March 27, 2012

RE: Comments on the Tentative Draft Permit for the Center for Aquatic Biology and Aquaculture (CABA) facility at the University of California, Davis in Yolo County.

Attachments: Figure
Flow Schematic

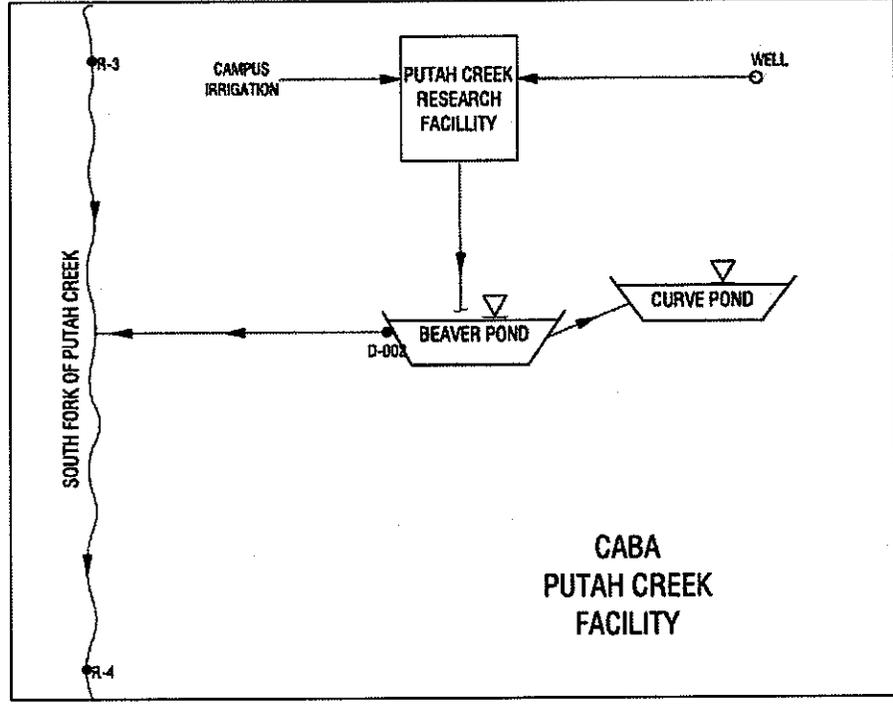
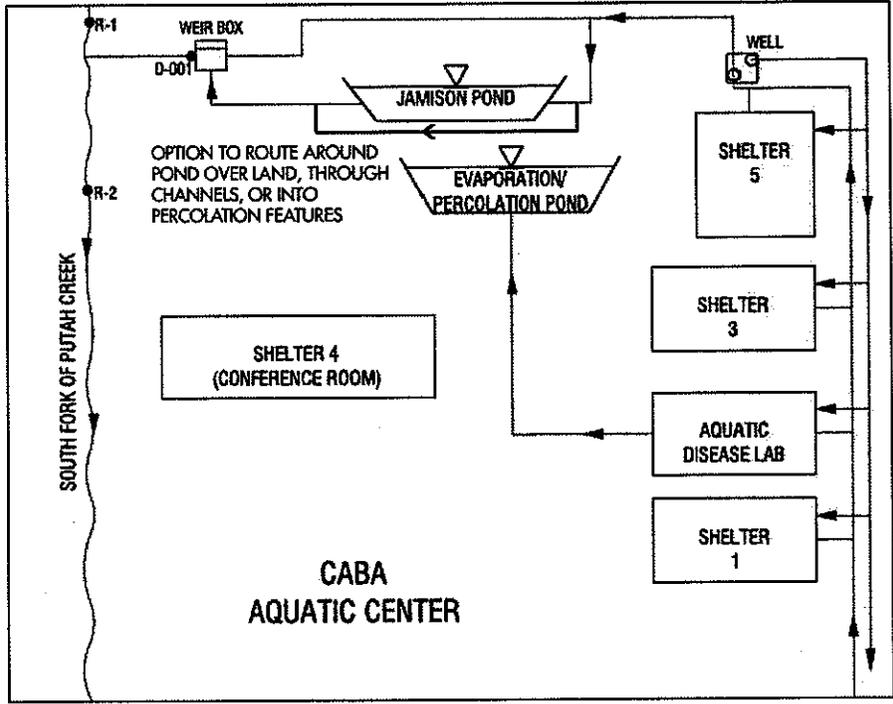
2. The university requests the ability to reroute wastewater from the Aquatics Center to the ground surface, with return water flow to Jamison Pond, in a limited area adjacent to Jamison Pond, depicted in red ink on the attached Figure, and as presented in the attached Flow Schematic. This may entail constructing channels and basins that will infiltrate a portion of the discharge stream. This flexibility will serve two purposes over the permit period:

- a. Allow the completion of a research project to study the effect of light levels on the establishment and growth of submersed aquatic plant propagules of one native species (*Elodea canadensis*) and one invasive species (*Myriophyllum spicatum*), with the hypothesis that survival and growth of propagules of both species will increase with greater light levels.

This project will take place on land adjacent to the UC Davis aquaculture facility and just west of Jamison Pond, and will begin in June 2012. Seven connected channels, each 25m long, 0.75m wide, and 0.6m deep, will be dug in this area, and water will be diverted to flow through these channels from the aquaculture center's water output.

- b. Allow for Study activities to occur in the area to evaluate the feasibility of reducing the amount of wastewater discharged to Putah Creek from the facility. Potentially, ponds and channels will be constructed and infiltration capacity evaluated under various flow and climate conditions.
